SERVICE BULLETIN

Inspection and/or replacement of the valve push-rod assy., rocker arm left and rocker arm right for ROTAX® Engine Type 912 i, 912 and 914 (Series)

ATA System: 72-30-00 Cylinder head

MANDATORY

Fig. 1
Visual inspection

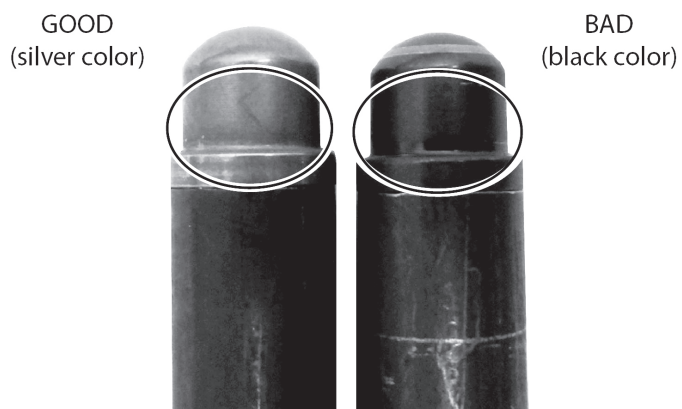
Perform visual inspection of all push-rod ball sockets on all cylinder.

Check for color. See Fig. 1.

Color	Evaluation
Silver surface	Valve push-rod is OK. No further action required for this valve push-rod.
Black surface	Valve push-rod is NOT OK. See section. 3.1.3) Replacement of affected parts.

Fig. 2

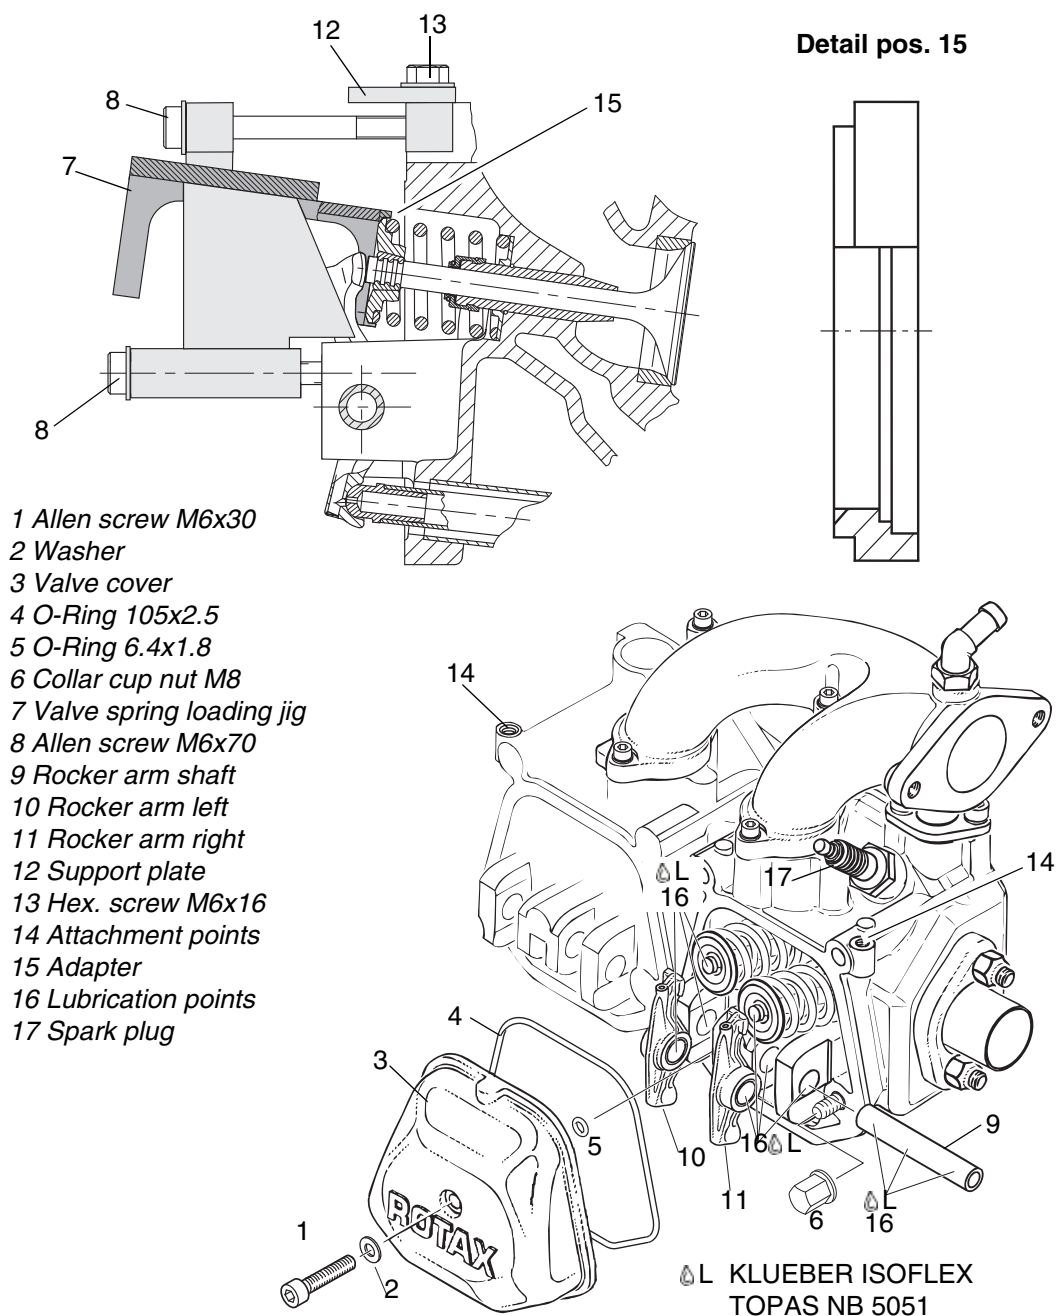
See [Fig. 2](#).

Step	Procedure
1	Loosen Allen screw (1) M6x30 with washer (2) from valve cover (3), and remove it together with large and small O-rings (4) and (5).

See [Fig. 2](#) and [Fig. 3](#).

On valve trains with valve push-rods found NOT OK the following steps need to be performed:

Fig. 3

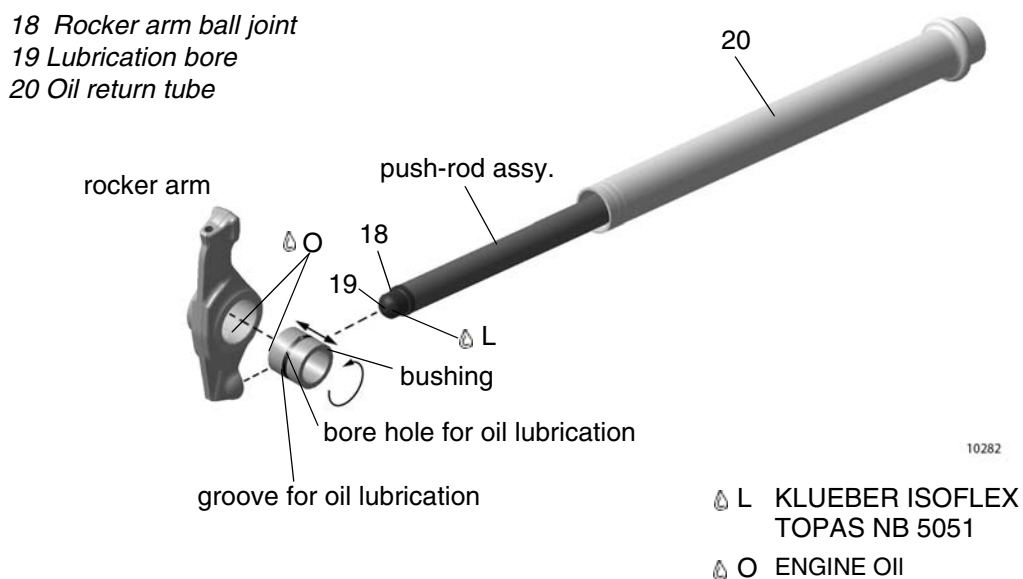
Step	Procedure
3	Attach the support plate (12) to the valve spring loading jig part no. 877387 (7) with 2 hex. screws (13) M6x16 at the attachment points (14) on the cylinder heads.
4	Put adapters (15) on the valve spring loading jig.
5	Attach the valve spring loading jig on cylinder head and support plate with 2 Allen screws (8) M6x70 and depress both valves with 3 turns.

Step	Procedure
6	This will relieve the pressure from both hydraulic tappets. Now the rocker arm shaft (9) may be easily pulled out. Lift out both rocker arms (10) and (11). NOTE: If you cannot pull out the rocker arm shaft easily, you will need to contact an ROTAX® Authorized Distributor for further action.
7	Replace all affected parts including push rods and rocker arms. See also Fig. 3.
8	Apply KLÜBER ISOFLEX TOPAS NB 5051 (16) on both push-rod ball sockets and contact areas of rocker arm and slide push-rod into the oil return tube (20).
9	Install rocker arm bushing into rocker arm left (10) and rocker arm right (11). Put oil on the rocker arm bushing.
10	Place rocker arm left (10) and rocker arm right (11) in cylinder head, apply KLÜBER ISOFLEX TOPAS NB 5051 (16) on rocker arm shaft (9) and insert it into its bearing support.
11	Loosen valve spring loading jig and support plate.
12	When removing the valve spring loading jig, make sure the adapter rings (15) do not jam on the valve spring retainer.
